PACKARD MOTOR CAR COMPANY
DETROIT, MICHIGAN

February 21, 1922

TO PACKARD DISTRIBUTERS

FRONT SPRING FRONT BRACKETS—EC TRUCK

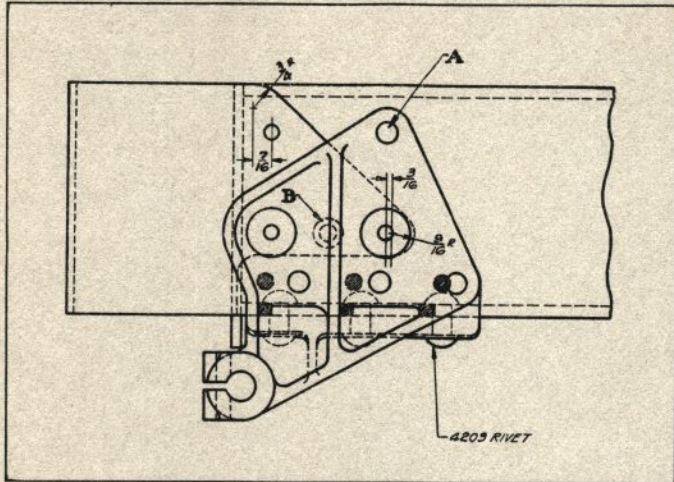
A new design front spring front bracket, which is already available in service stock, has been developed for the size EC truck. The new bracket will go into production shortly. As can be seen from the illustration, the new design has better rivet spacing, and attaches to the frame side member above as well as below the center line of the web.

In making the installation, the old bracket should first be removed, and all of the old rivet holes filled by welding, and the web surface made plane and smooth. The rear upper corner of the bumper bar should then be sawed off diagonally, as shown, in order to expose the rivet hole in the frame marked "A", since this hole is used in mounting the new bracket. The round headed rivet remaining in each end of the bumper bar assembly at "B" must then be removed and the holes countersunk to take Pc. No. 5161 rivet, in order to permit the bumper bar to clear the new spring bracket.

When installing the new unit, the bracket may first be temporarily bolted on at "A", since this is the only one of the old holes used with the new mounting. The remainder of the holes can then be located and drilled. The new bracket, like the old, should be secured to the frame by careful hot riveting. Seven rivets, Pc. No. 4203, are required per bracket.

Only the new style bracket will in the future be supplied from service stock, and the piece numbers listed in the latest issue of the truck service parts list cover the new design.
